Execution Ethernet Interfaces CANopen Master

1. Standard Ethernet TCP/IP interface with CANopen Master

Typedesignation: BM4-O-ETH-02-00-00

Part No.:365815

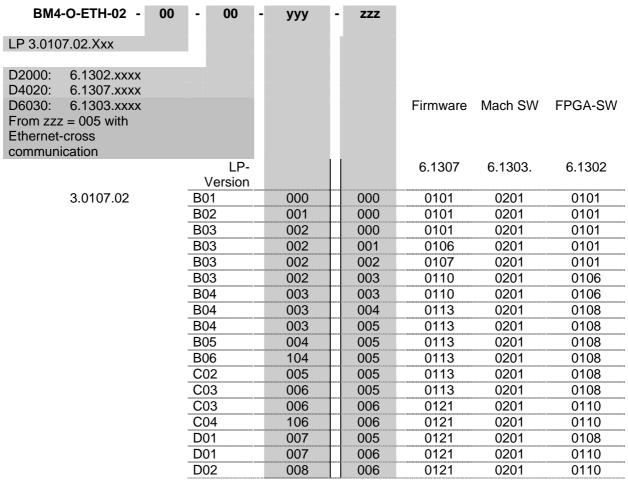
The printed circuit board 3.0107.02.B02 is introduced with AT161 03 from March 31, 2003.

• Adaptation of the parts list to the series production

The printed circuit board 3.0107.02.B03 is introduced with AT441_03 from October 01, 2003.

• Internal change of the plug (solder instead of press)

The printed circuit board 3.0107.02.B04 is introduced with AT076 05 from April 04, 2005.

Optimized boot behavior (Reset level at the option modules)

The printed circuit board 3.0107.02.B05 is introduced with AT434_05 from December 16, 2005.

Optimized for internal test equipment (additional resistors)

The printed circuit board 3.0107.02.C02 is introduced with AT434 05 from December 16, 2005.

Optimized for the procedure of production

The printed circuit board 3.0107.02.C03 is introduced with AT196_06 from June 27, 2006.

Optimized assembly

The printed circuit board 3.0107.02.D01 is introduced with AT196_06 from June 27, 2006.

Optimized Lavout

The printed circuit board 3.0107.02.D02 / C04/ B06 is introduced with AT215 07 from July 24, 2007.

Correction for error pattern ,Prozessor Abort During Data Access'

The FPGA-software 1.06 is introduced with AT076_05 from November 17, 2003.

- Synchronization behavior improves with restart of the synchronization
- Improvement of the BACI-Timing

The FPGA-software 1.08 is introduced with AT194_05 from June 17, 2005.

• Improvement of the signal quality (influence of the temperature)

The Firmware-software 1.06 is introduced with AT489_03 from the November 14, 2003.

• Extension of the functionality on Multi Axis Motion Control

The Firmware-software 1.07 is introduced with AT111_04 from the February 26, 2004.

Adaptation of the recognition of new flash types

The Firmware-software 1.10 is introduced with AT076_05 from April 04, 2005.

- Synchronization behavior improves with restart of the synchronization
- Improvement of the BACI-Timing

The Firmware-software 1.13 is introduced with AT367_04 from June 22, 2005.

Qualities of all Firmware-versions (standard and cross communication) combines on a single firmware

The Firmware-software 01.21 is introduced with AT073_07 from March 02, 2007.

- CANopen configurable with ProMaster
- Support of MotionControl
- CANopen Automatically net work management
- CANopen synchronization of process communication in IEC for 256RxPDOs and 256TxPDOs
- CANopen communication profile DS301, DSP 302 and application profile DS405

Typedesignation: BM4-O-ETH-02-00-01

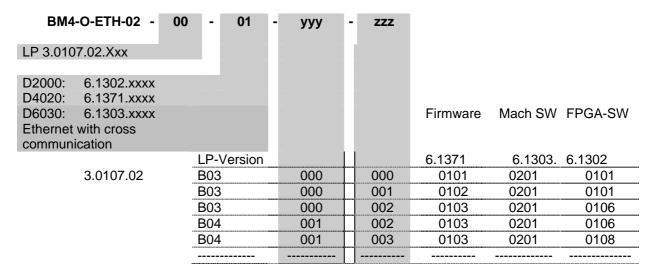
The printed circuit board 3.0107.02.B04 is introduced with AT076_05 from April 04, 2005.

Optimized boot behavior (Reset level at the option modules)

The FPGA-software 1.06 is introduced with AT076_05 from November 17, 2005.

- Synchronization behavior improves with restart of the synchronization
- Improvement of the BACI-Timing

The FPGA-software 1.08 is introduced with AT194_05 from June 17, 2005.

• Improvement of the signal quality (influence of the temperature)

The Firmware-software 1.02 is introduced with AT111 04 from February 26, 2004.

Adaptation of the recognition of new flashtypes

The Firmware-software 1.03 is introduced from May 19, 2005.

Compatibility of new FPGAs
